DRB CASE ACTION LOG - BLUE SHEET

Project #: 1007488 Application #: 12DRB-7072
Project Name: Sisters of the Order of St. Dominic
Agent: DKKER Pouch Sabatini Phone #:

**Project #1007488 12DRB-70172 Amended Site Development Plan for Building Permit –
Lot(s) D-1E-1, Sisters of the Order of St. Dominic zoned SU-2/IP-EP**

Re: DRB Re-submittal to address comments from 6/20/2012 hearing
Request for Amended Site Development Plan for Building Permit
Project # 1007488; 12DRB-70172

SHEET KEYED NOTES

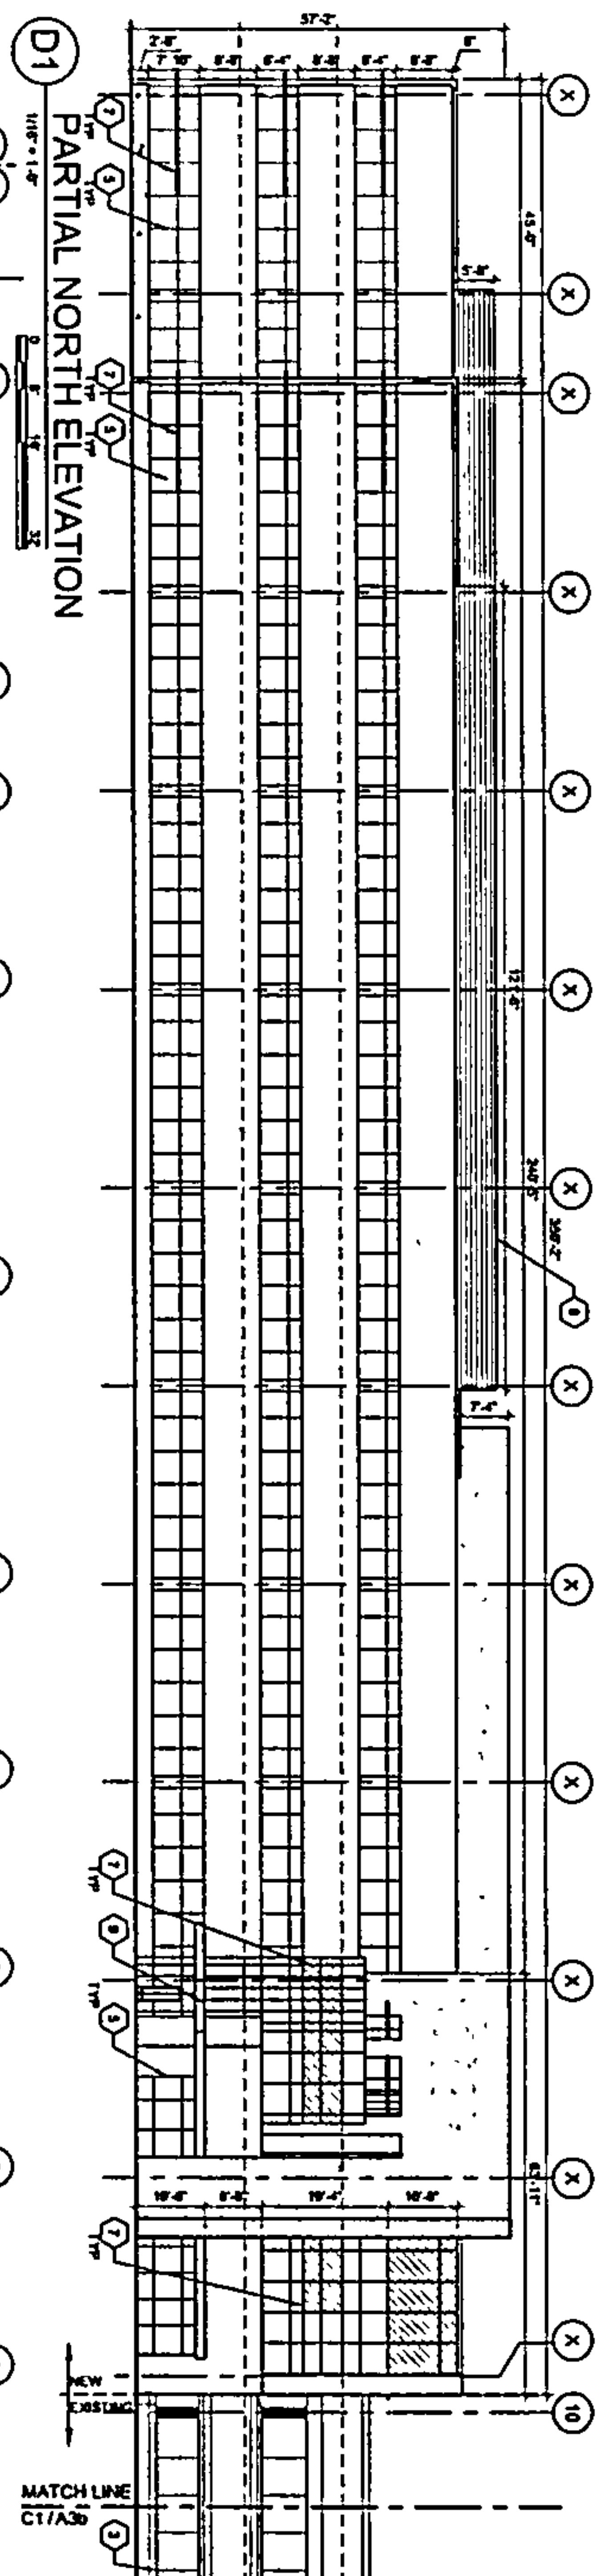
- 1. Height shown for new building is 57' 2" which exceeds the North I-25 Sector Development Plan 3 story height limit of 39' which is a concern for balloonists safety.**

- iv. Building sign letter size: the Site Development Plan elevations have been revised to limit the sign letter size to 18" per the Design Regulations.

- v. Building sign height: the Site Development Plan elevations have been revised to locate the building mounted signs between the second floor level and the first floor ceiling, per the Design Regulations.

- vi. Building height overlay: as noted above, we are following the existing zoning compliance path, which allows the building height per the requirements of the Zone Code, per section 4.3 of the Sector Plan.
